APPLICATION FOR CONSIDERATION
NOTICE OF DECISION
OFFICER REPORT

| Proposal | Use and development of a Child Care Centre | |
| Application Number | T220667 | |
| Land/Address | Lots 101 & 102 PS515605, 24-26 Honeyeater Way, Pakenham VIC 3810 | |

Image 7 – Ground Level Acoustic Barriers

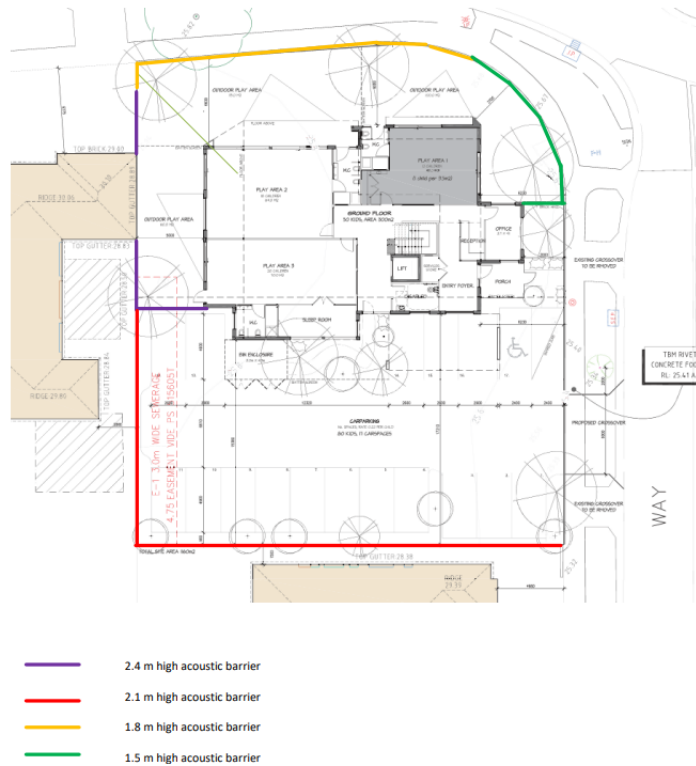
Noise from children's activities in the outdoor play areas is predicted to comply with all identified noise limits provided that the proposed acoustic barriers and balustrades are constructed.

Acoustic barriers with a height of 2.1 m have been recommended for parts of the west and south boundaries of the subject site to control noise from motor vehicle activity during the night period (6:30 am to 7 am), when sleep disturbance criteria may be relevant. Whilst the fencing is high, the structures provide an appropriate level of noise mitigation in response to the car parking and outdoor play areas from the child care a use. The fencing also addresses concerns relating to privacy and overlooking.

- ii. Measures to address overlooking and noise mitigation.
 - b. Modification to the acoustic fencing in north-west corner of the land to provide visibility splay for neighbouring property to the west.
